Date: 17 November 2025
Arcadis Ref: 30255527 (122047-prev.) – Task 0019
Subject: Devens Peer Review
CFS-3 – 125, 111 and 105 Hospital Road
Parcel ID 018.0-0007-0200.0

Arcadis has reviewed the preliminary submittal for 117 & 125 Hospital Road – Level 2 Unified Permit Application Documents dated October 23, 2025, including the following supporting documents:

1) 3.02 (3) (b) 6 (a). – Landscape Treatment

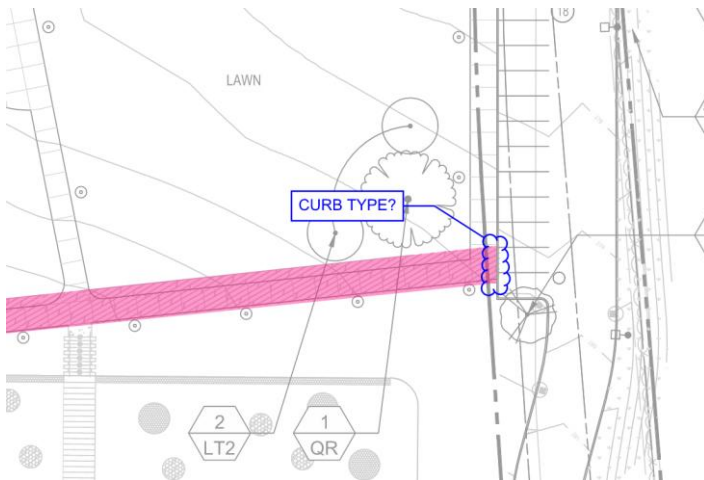
All existing landscape features, especially existing trees and woodland to remain, shall be shown on ALL site plan sheets....Scattered trees to be preserved shall also be shown as well as all “specimen trees” (trees exceeding a minimum caliper of 12”) within 100’ of existing or proposed lot lines have been identified and indicated.”

- a) Tree protection detail shows tree protection fence at tree dripline. Tree protection fencing is required to be 12" minimum beyond dripline of trees.

The tree protection detail has been revised to show the 12" minimum beyond the dripline of trees.

3) 3.04 (6) (a) 3 (a). – Lighting.

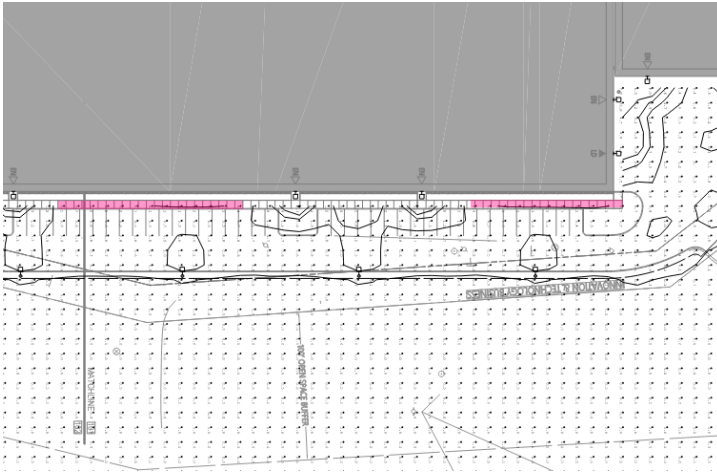
Access Road/Parking lighting shall be 0.5-foot candles minimum (maintained), with 30' maximum height posts.

- a) Indicate which lights (if any) shall remain on overnight.
 - i) Since the facility is a 24/7 facility, the lights will be on overnight and shall use a photocell to turn off when sufficient daylight allows. A sheet note will be added to the plans to indicate this.*
- b) Proposed and existing trees to remain shall be included on site lighting plans and photometrics to ensure no conflicts.
 - i) Concur, proposed and existing vegetation will be added to the plans.*
- c) On Sheets ES111 and ES112, foot candles far under 0.5 are shown on walkways along East side of the proposed building. Provide lighting to ensure safely lit walkways along this façade. Areas highlighted in pink (plan rotated, North is page right):

To illuminate the areas highlighted in pink, additional wall packs will be required. We recommend that these additional wall packs be on occupancy sensors to minimize façade illumination. These will be indicated on the plans, complementary to item (a) above.

4) 3.04 (6) (a) 3 (b). – Lighting.

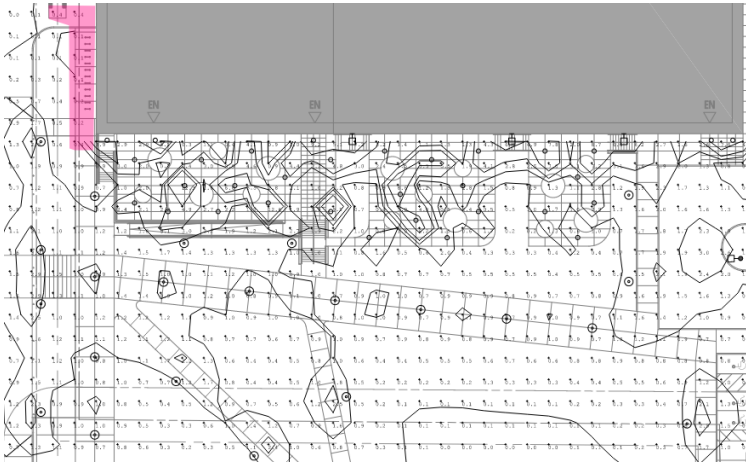
Walkway lighting shall be 0.5 foot candles minimum (maintained, with 15'-18' high posts.

- a) Indicate which lights (if any) shall remain on overnight.
 - i) Since the facility is a 24/7 facility, the lights will be on overnight, and shall use a photocell to turn off when sufficient daylight allows. A sheet note will be added to the plans to indicate this.*
- b) Proposed and existing trees to remain shall be included on site lighting plans and photometrics to ensure no conflicts.
 - i) Concur, proposed and existing vegetation will be added to the plans.*
- c) On Sheets ES111 and ES112, foot candles far under 0.5 are shown on walkways on the Southwest corner. This bike parking area should be well lit to ensure cyclists have ample light to lock/unlock their bikes easily and safely. Area highlighted in pink below:

To illuminate the areas highlighted in pink, additional wall packs will be required. We recommend that these additional wall packs be on occupancy sensors to minimize façade illumination. These will be indicated on the plans, complementary to item (a) above.

4) 3.04 (8) (e) 3. – Soil Testing

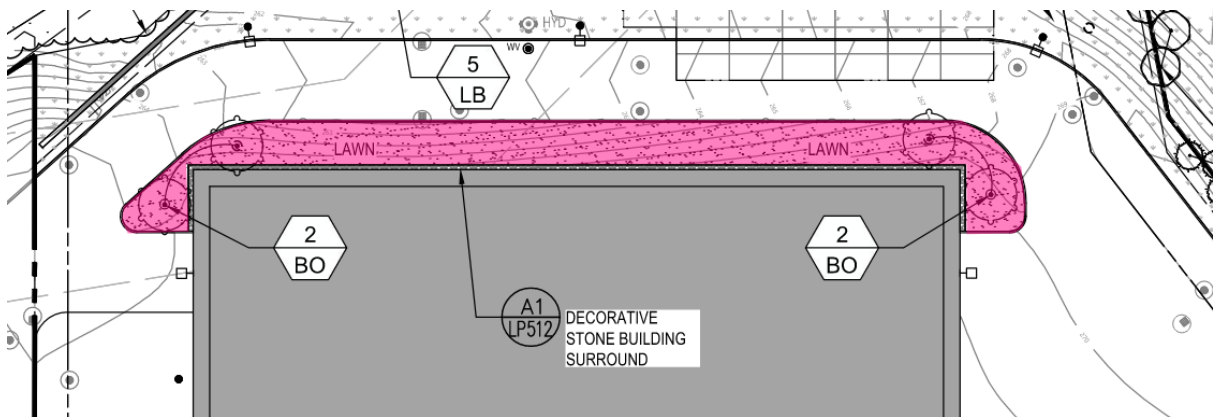
In order to select plant material that is appropriate for the climate, soil type, light, exposure, and gradient of the site, the Applicant shall have the existing soil tested for both mechanical sieve and chemical analyses by an independent testing laboratory.

- a) Confirm that soil testing has been conducted and plant material has been selected based on the soil test results, specifically the New England Wetland Plants Wildflower Mix.

Topsoil test reports for the CFS site for the CFS-2 project have been provided to the CFS-3 design team. Soil tests were performed by UMass Amherst and dated May 2, 2025. The reports indicate test results along with recommendations for amendments. I reviewed the test results with New England Wetland Plants, and they indicated that the pH and organic matter content are acceptable. Further, NEWP indicated that too many additional inputs or amendments could potentially harm or burn the seed.

5) 3.04 (8) (f) 3. – Slope Stabilization

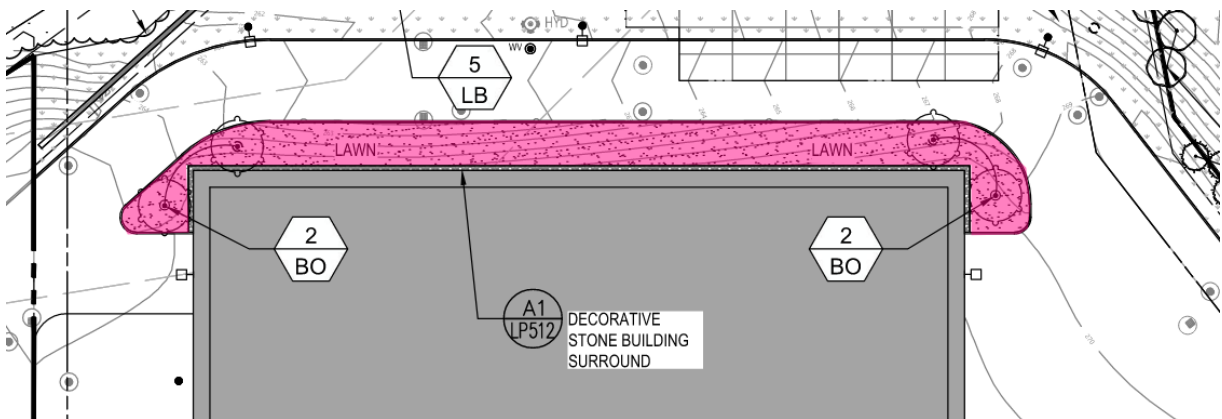
- a) Planted area at North side of building is graded at $\pm 1:3$, which is recommended to be planted with slope stabilizing material. Precise 1:3 slopes are difficult to achieve uniformly with site grading, and may become greater than 1:3 over time, leading to maintenance issues. Additionally, establishing a seeded lawn on a slope of $\pm 1:3$ is challenging; consider proposing a no mow seed mix intended for steep slopes, and/or additional plantings of native shrubs and groundcovers with fibrous root systems.

- b) Confirm that 50:50 New England Wetland Plants Wildflower Mix and Erosion Control Mix for dry sites proposed at all areas to be re-graded is appropriate for 1:2.5 slopes. Consider a 100% Erosion Control Mix on steep slopes at or over 1:3, and Meadow Mix in areas under 1:3.

Per comment #6, and per item (a) above, the highlighted area will be planted with deciduous and evergreen trees to help screen the garage. The understory layer will be planted with groundcover and native shrubs to stabilize the slope.

We agree with 100% Erosion Control Mix on steep slopes at or over 1:3, and 100% Meadow Mix in areas under 1:30.

9) LP102 LANDSCAPE PLAN ENLARGEMENT 2

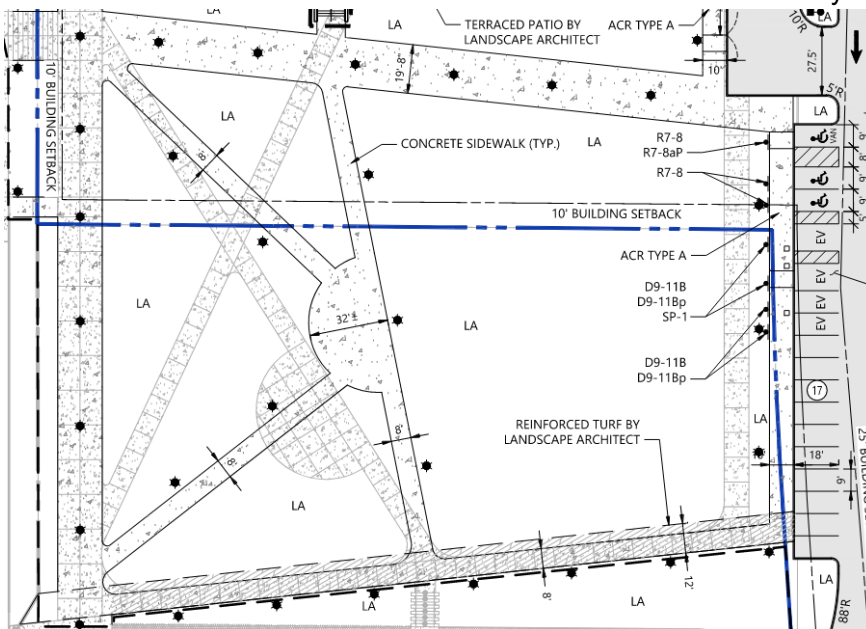
- d) Some plans currently show proposed quad walkways and screened back walkways, but it is unclear which is correct. Please differentiate between/label the two walkway layouts shown.

The screened back sidewalk in the campus green was part of a previously permitted design and was included to illustrate the changes proposed by this project. However, we understand that this has caused confusion and will remove the unnecessary linework from the plans.

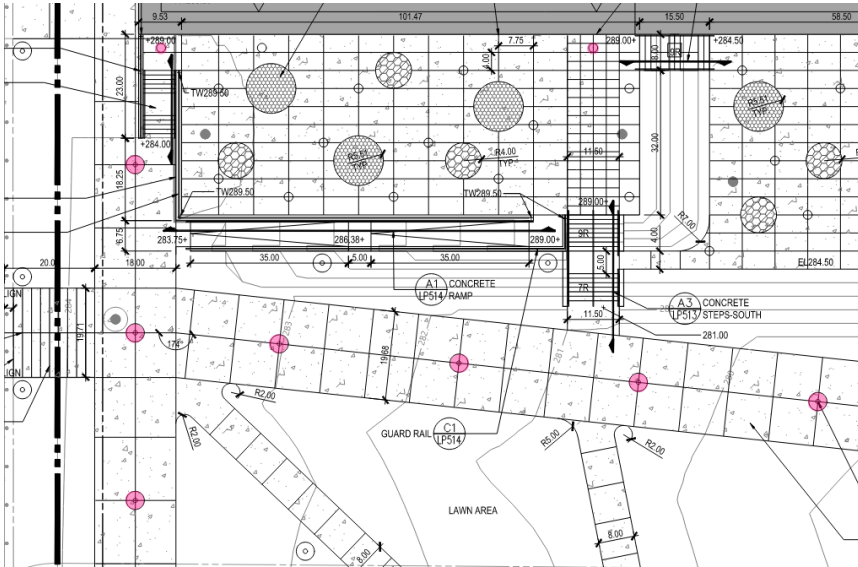
- e) At terrace and quad south of proposed building, light poles are proposed in the middle of walkways. This layout is not feasible from a maintenance perspective, especially snow plowing. Consider shifting light poles off walkways and off center of path of travel for consistency and ease of maintenance.

The centered lights within the pavement are part of a concept previously approved by CFS to create promenades connecting the campus buildings. These paths are 20 feet wide which offer ample space for snow maintenance on either side of the poles. The concrete bases extend above the paved surface and will help to protect the poles from damage.

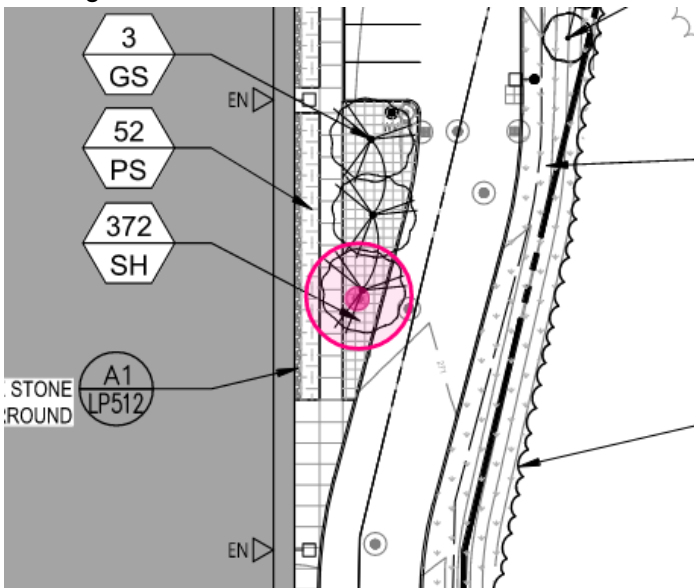
- f) There is a potential conflict between 1 Ginkgo and a manhole at planted island on East side of building.

Concur, the tree will be adjusted or removed to eliminate the conflict.
